Indiana Steel & Wire
VRP# 6960203
File Code: 100

Re: Mocks Pond Post-Construction Monitoring
Indiana Steel and Wire Site
Muncie, Delaware County
VRP #6960203

The Indiana Department of Environmental Management's (IDEM's) Voluntary Remediation Program (VRP) staff has completed review of the Mocks Pond Post-Construction Monitoring Report, dated January 24, 2006, for the Indiana Steel and Wire Plant Site, prepared by you on behalf of GK Technologies, Inc. (GK). This report details the results of the post-construction monitoring and bathymetric survey conducted in October 2005.

FIGURE 7

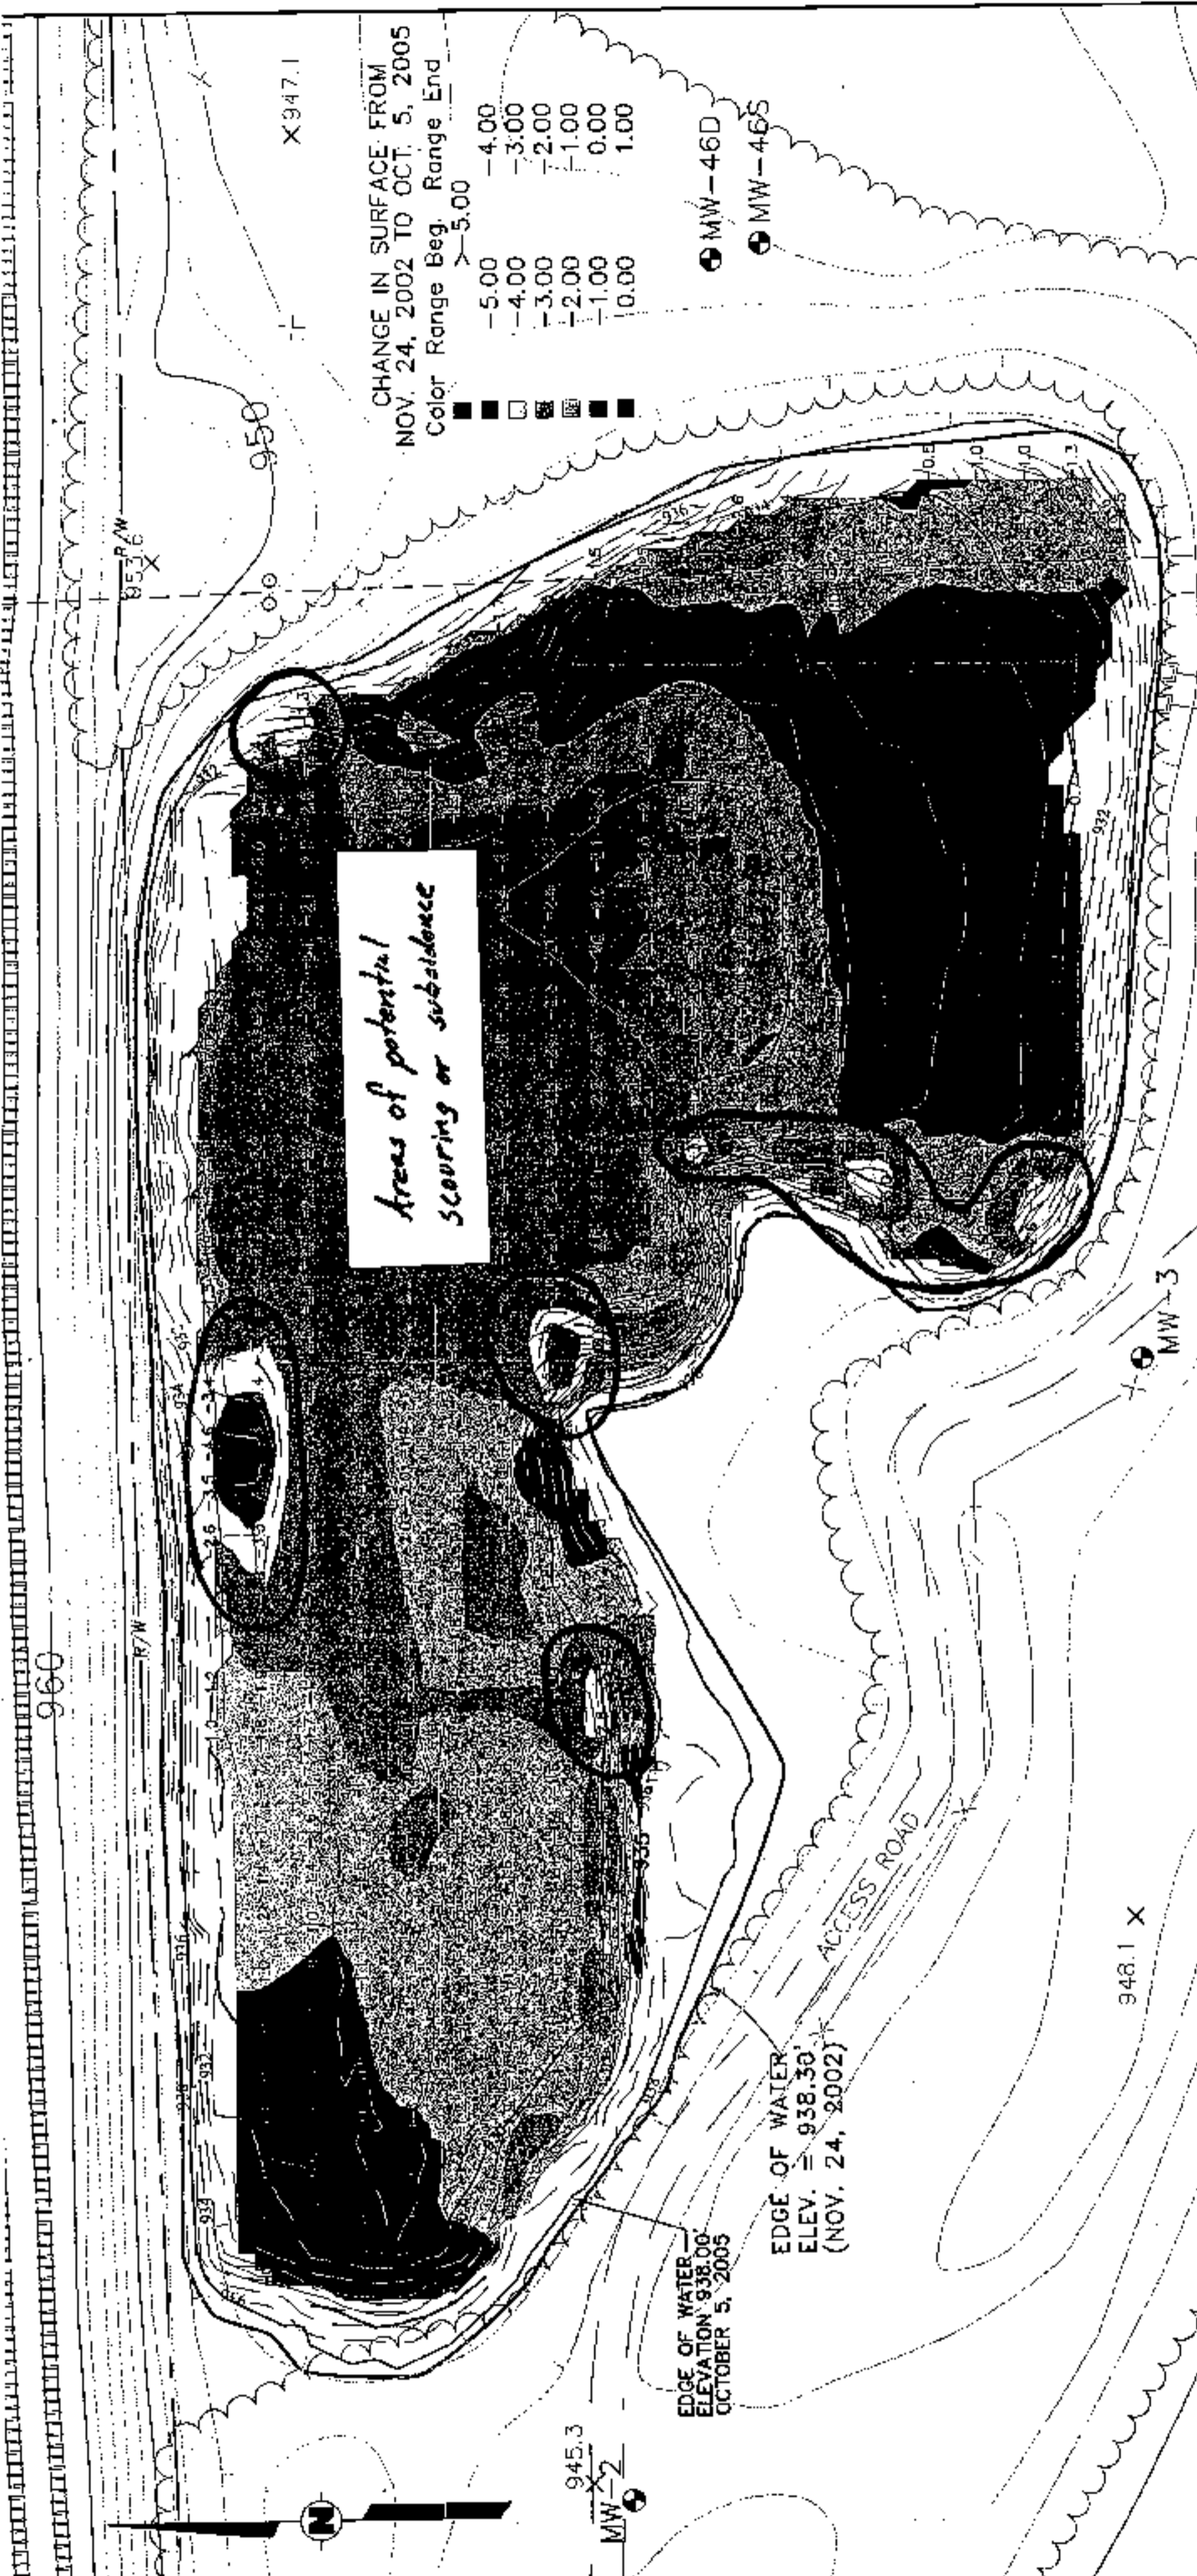
The VRP has no specific comments regarding the sampling methodology or analytical results from the sediment, pore water, and surface water sampling. The bathymetric survey does identify areas of possible scour and/or subsidence. Due to the current lack of information regarding the sand cap thickness uncertainly exist as to the condition of the cap in these areas. As previously discussed, the thickness of the sand cap must be determined throughout Mocks Pond. This cap thickness data will make the bathymetric survey interruptions more meaningful.

It is VRP understands that GK intends to conduct a geophysical survey and physical probing of Mocks Pond this year to map the sand cap thickness. During these activities, the VRP is specifically requesting that physical probing also be conducted in those areas of apparent scour or subsidence and that the condition of the sand cap and geotextile liner be evaluated. The VRP has copied Figure 7 and circled these apparent scour or subsidence areas needing investigation. Please see attached.

Areas of potential
scouring or subsidence
